**In reply please quote:** 19/29449  
**Your reference:** SSI-9364

## **M12 ENVIRONMENTAL IMPACT STATEMENT (EIS) – MAJOR INFRASTRUCTURE PROJECT**

Council at its meeting of the 10 November 2020 endorsed the matters outlined in this letter, as the basis for a submission to the M12 EIS Submissions and Amendment Reports.

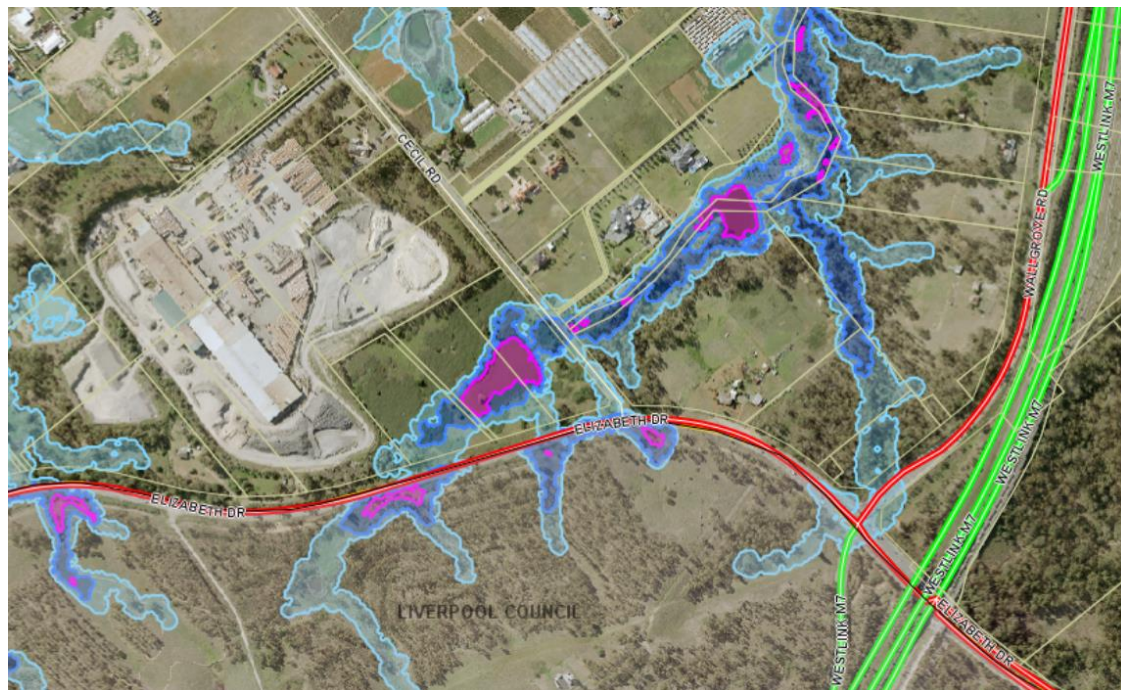
The proposed western re-alignment of Wallgrove Rd also impacts on tributary to Ropes Creek as well as an existing artificial wetland (farm dam). The technical studies associated with the amended proposal do not clarify the extent of impacts on stormwater management and flooding issues in this area.

However, the following image taken from Council's land information system shows the extent of flooding impacts along this tributary from its western extent across to the current alignment of Wallgrove Rd.

Based on the above, Council requests that TfNSW undertake further investigations into the impacts of the realignment of Wallgrove Rd on flooding issues, both upstream and downstream of the location.

This includes consideration of culverts or viaduct structures along the realigned section of Wallgrove Rd to mitigate flooding impacts and maintain the function of the Ropes Creek tributary as a natural watercourse.
